**Re: FortisBC Energy Inc. Application for a Certificate of Public Convenience and
Necessity for the Inland Gas Upgrade Project**

FINAL SUBMISSIONS

**Application for a Certificate of Public Convenience
and Necessity for the Inland Gas Upgrade Project**

Figure 2: Interior Dig Locations (64 active and 12 passive corrosion sites)

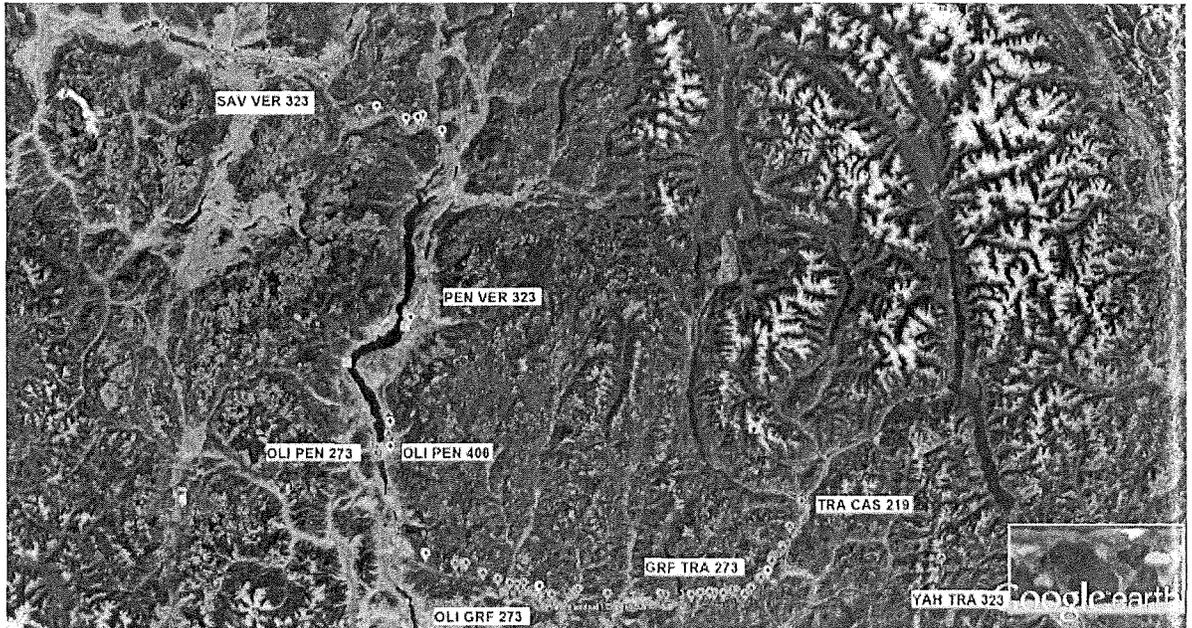
42. FEI has also provided evidence of both active and passive corrosion.
43. Figure 2 demonstrates 64 active and 12 passive corrosion sites in the Interior of BC.

44. FEI does not have a reliable way to detect where corrosion is occurring.²⁰
45. FEI’s engineering team’s assessment is that the 29 Transmission Laterals are susceptible to failure by rupture due to external corrosion that in some cases is undetectable by FEI’s current integrity management practices for these pipelines.²¹
